City of Portland, Maine - Building or Use Permit Application
 389 Congress Street, 04101 Tel: (207) 874-8703, Fax: (207) 874-8716

**CITY OF PORTLAND, ME
BOCA 1999 Plan Review Record
One and Two Family Dwelling**

Building Description: Single Family dwelling/attached garage.

NEW RESIDENCE FOR:
WALPE RESIDENCE
PORTLAND, MAINE

PLOT PLAN
OF:
LOT 20 AUBURN PINES SUBDIVISION
AUBURN PINES DRIVE
PORTLAND, ME.
FOR:
ANNE WALP
20 WENDELL ST.
PORTLAND, MAINE 04103

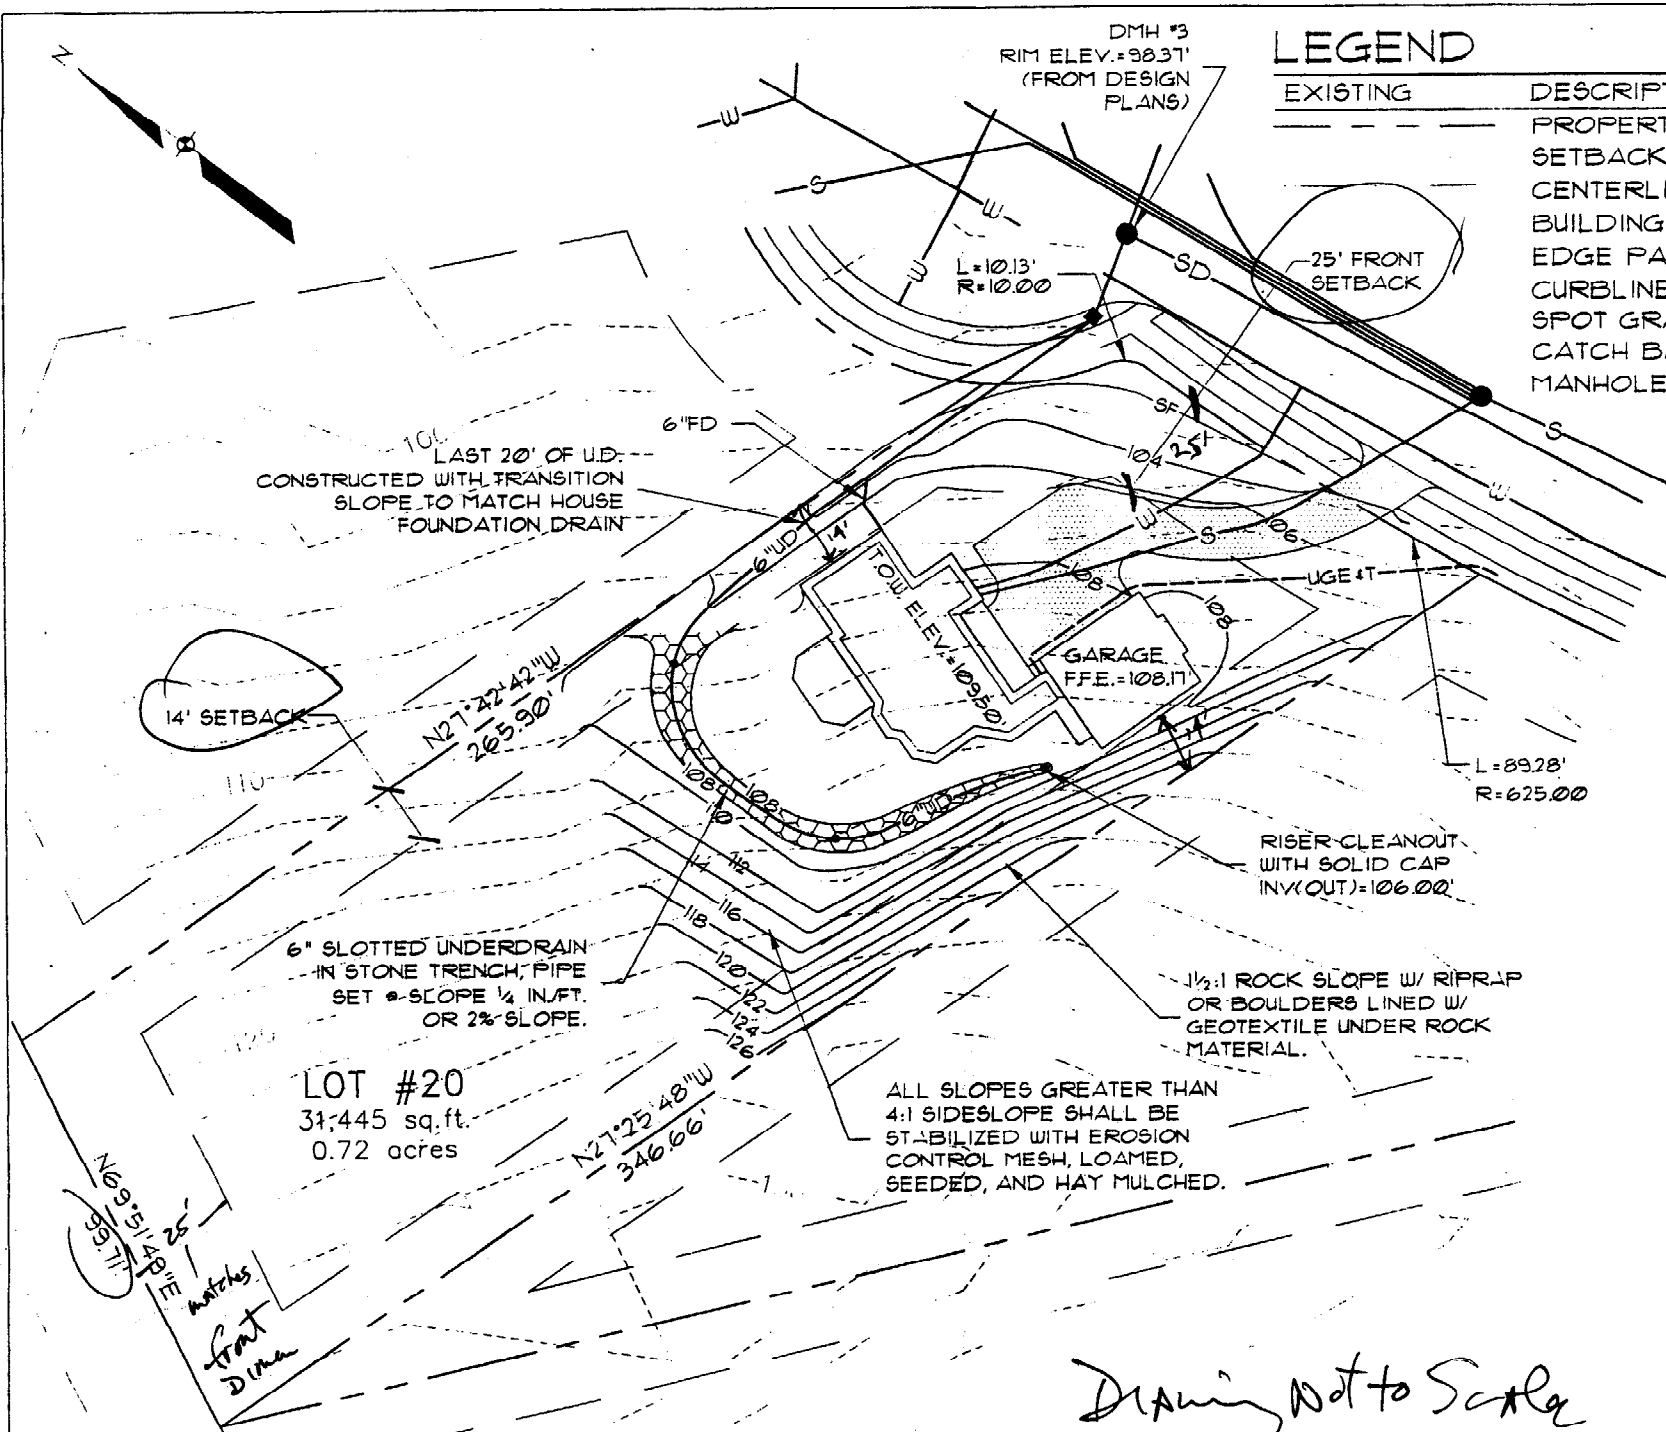
→ close Side Yard - 14' req - just over 14' on both sides
2 story shown

FIRST FLOOR PLAN
SCALE: 1/4" = 1'-0"

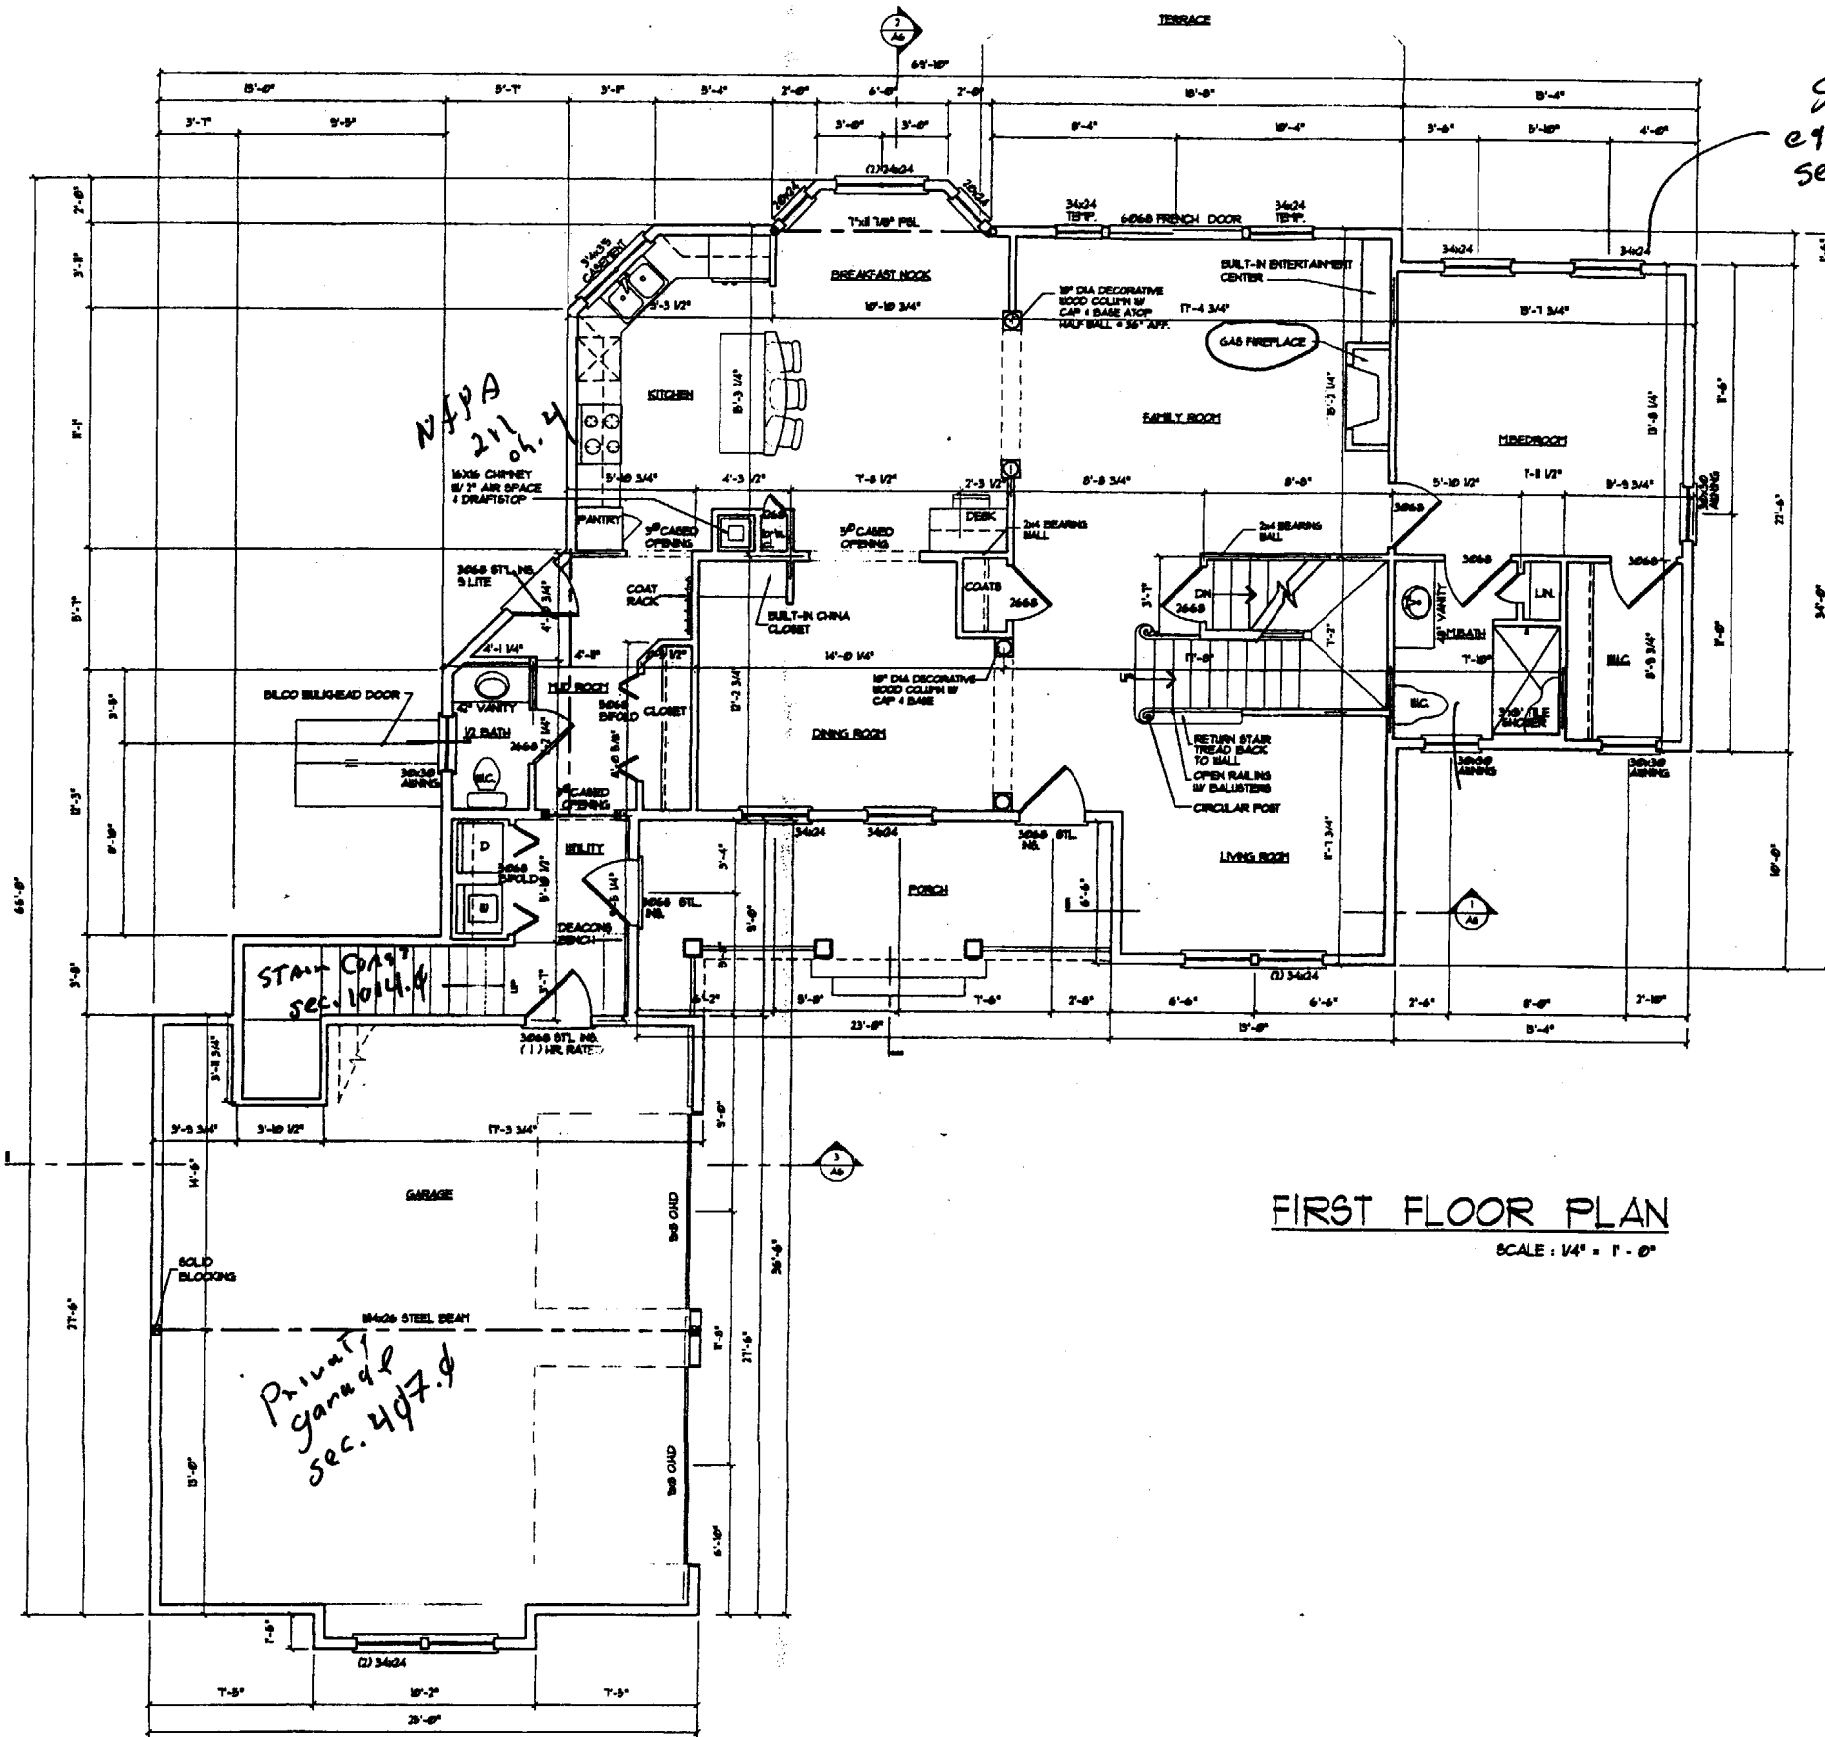
Sleeping room egress or rescue windows section 1010.4

DRAWINGS THIS SHEET
**SECOND FLOOR PLAN /
 FRAMING PLAN**

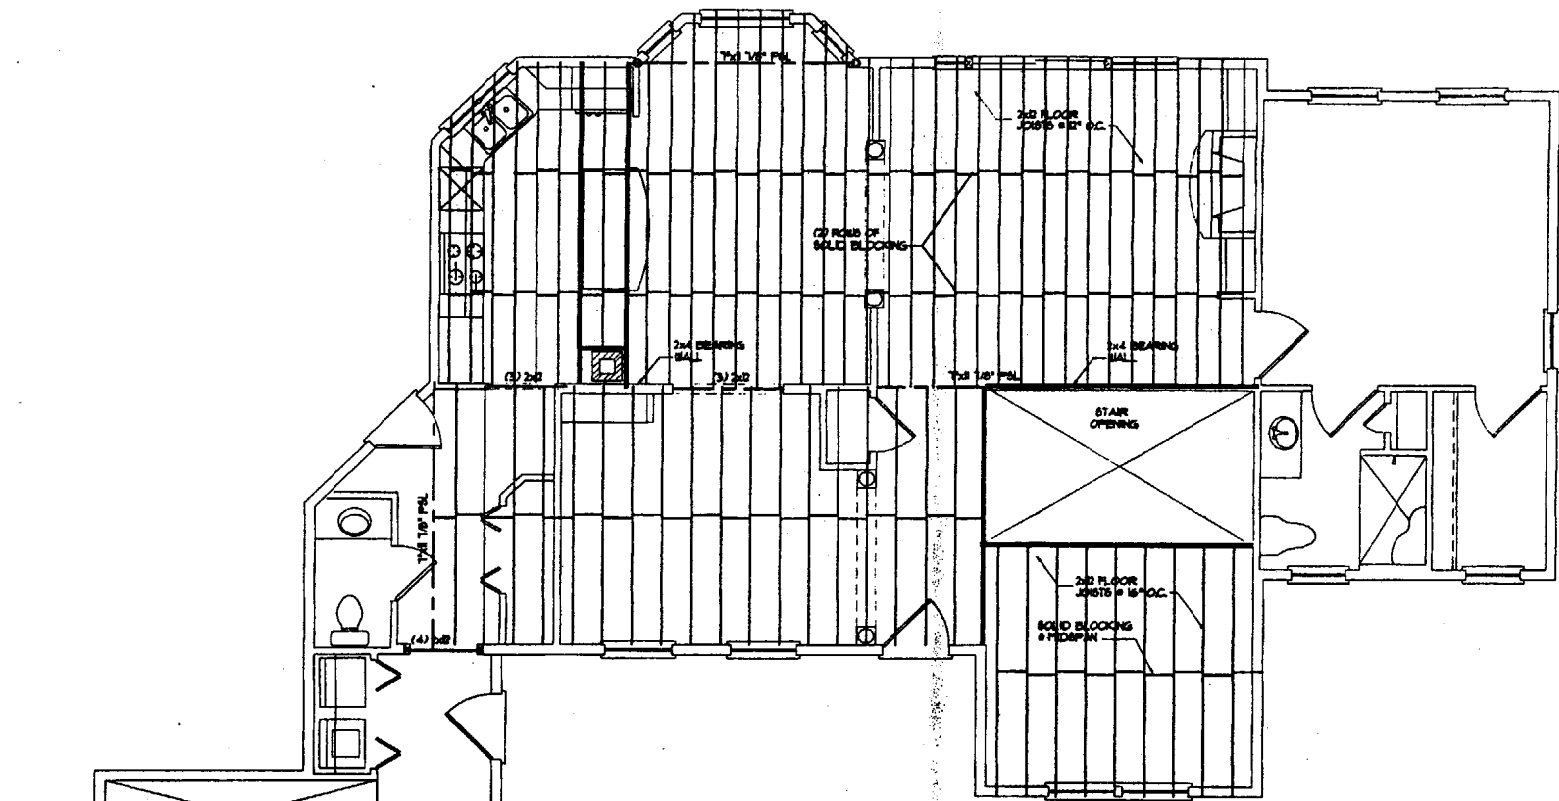
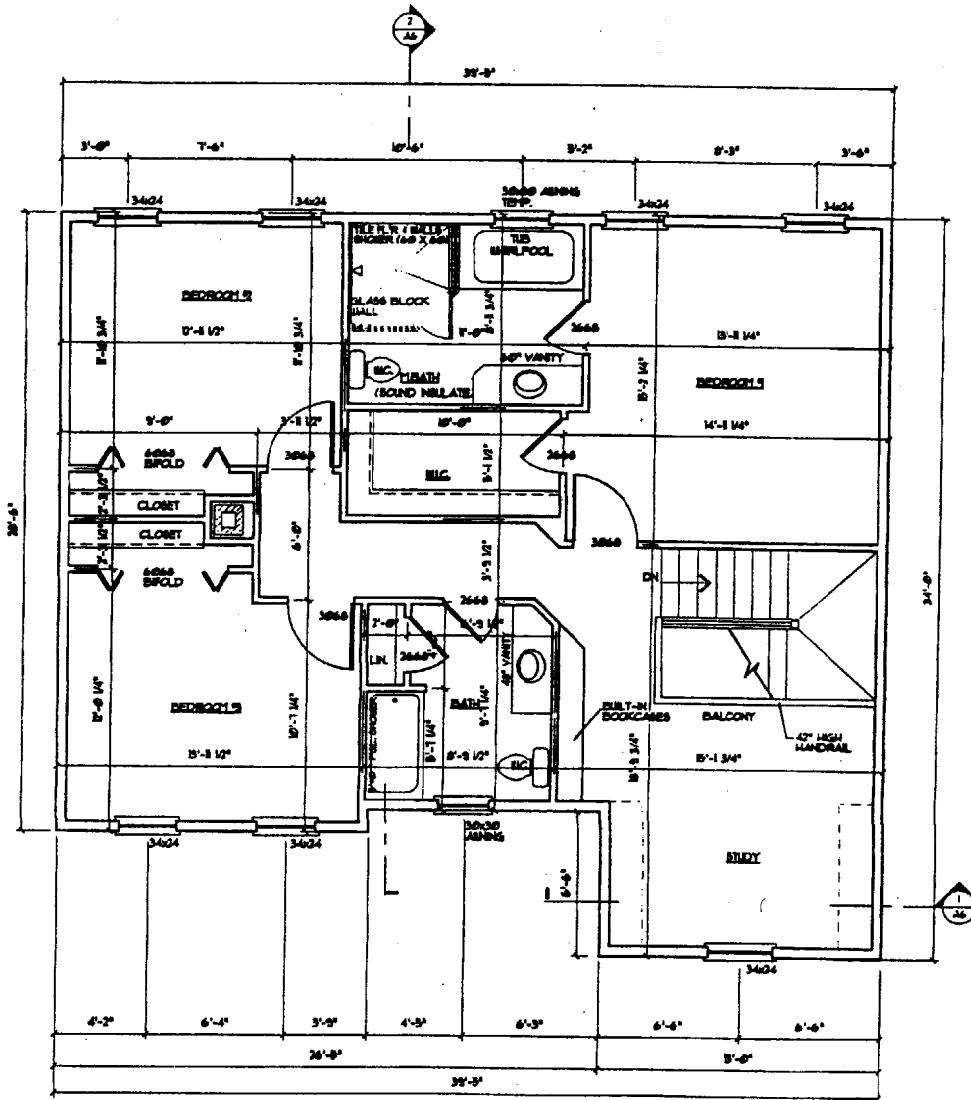
This will require a design statement from a professional engineer. SCALE: 1/4" = 1'-0"

LEFT SIDE ELEVATION
SCALE: 1/4" = 1'-0"

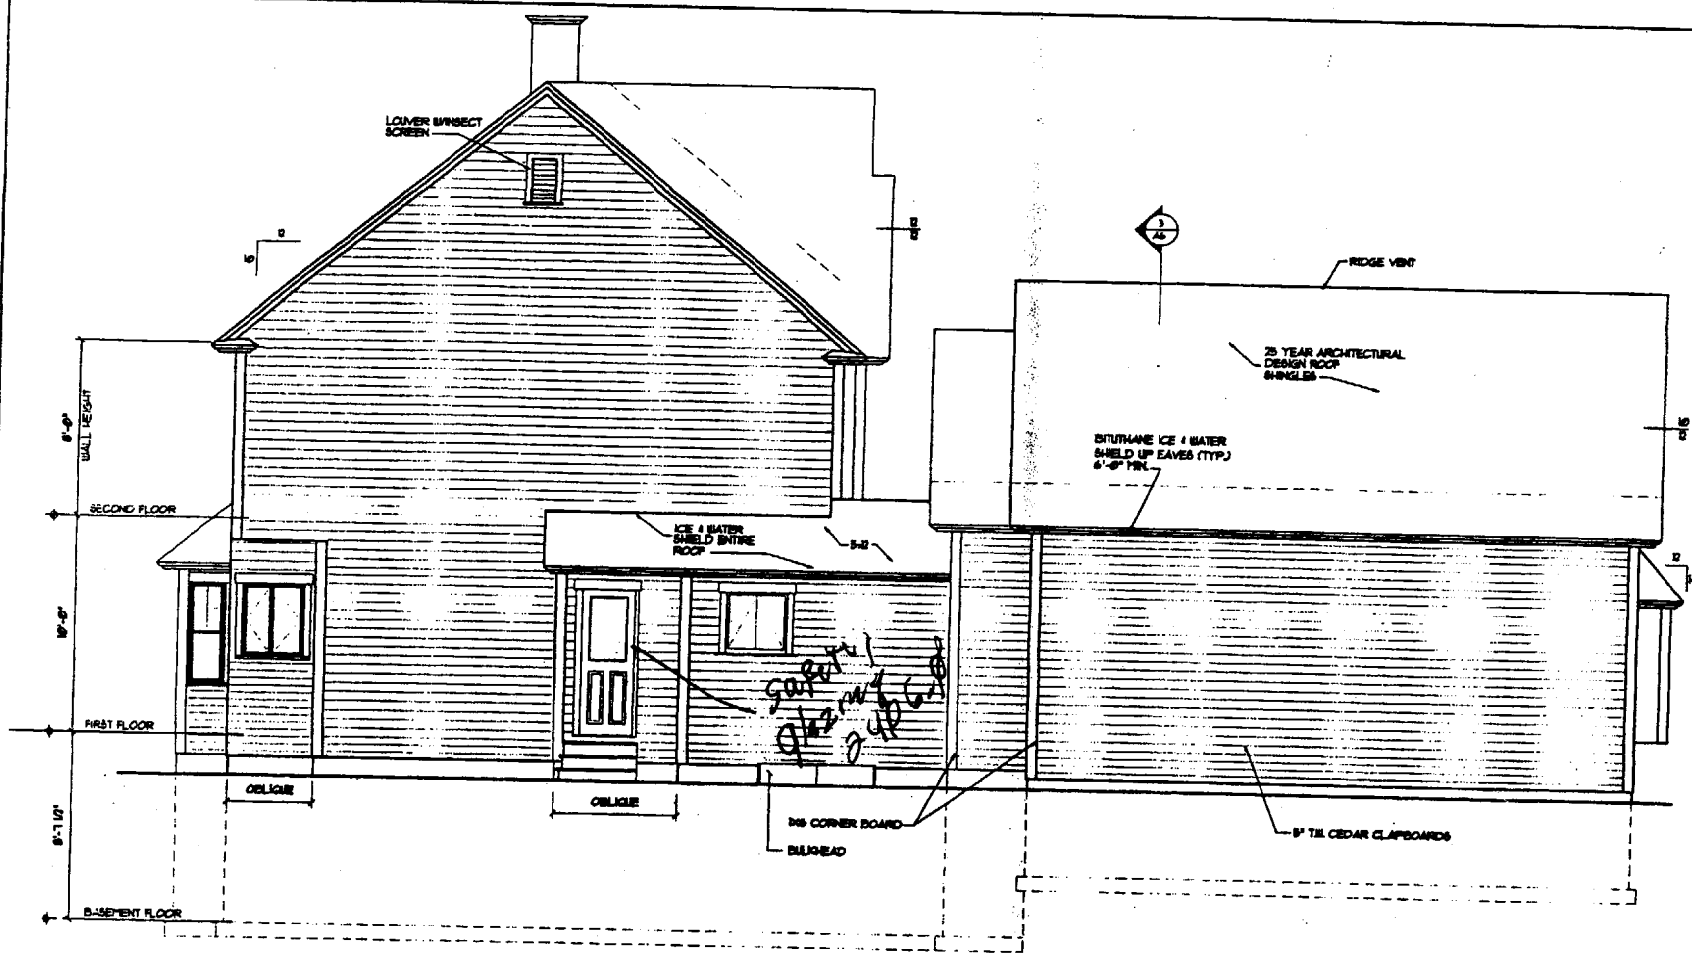
*Flashing sec. 1406.3.10
Roofing sec. 1505.4*

FRONT ELEVATION
SCALE: 1/4" = 1'-0"

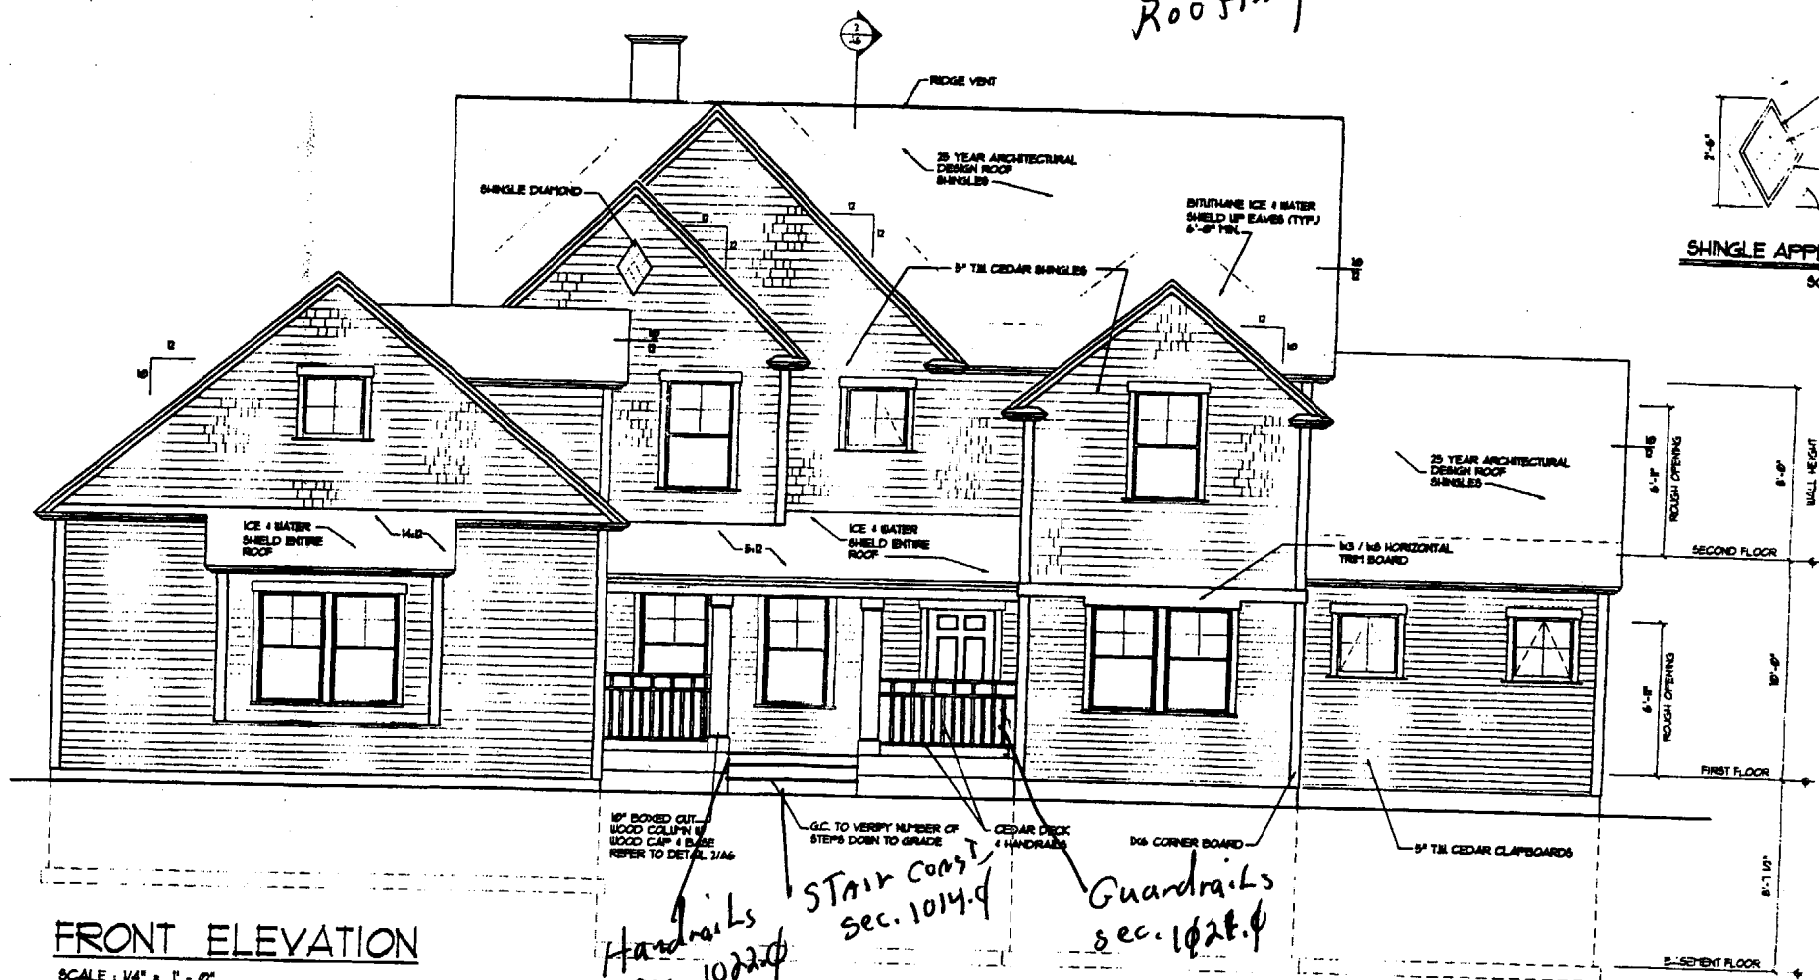
*Handrails sec. 1022.0
Stair case sec. 1014.4
Guadrails sec. 1028.0*
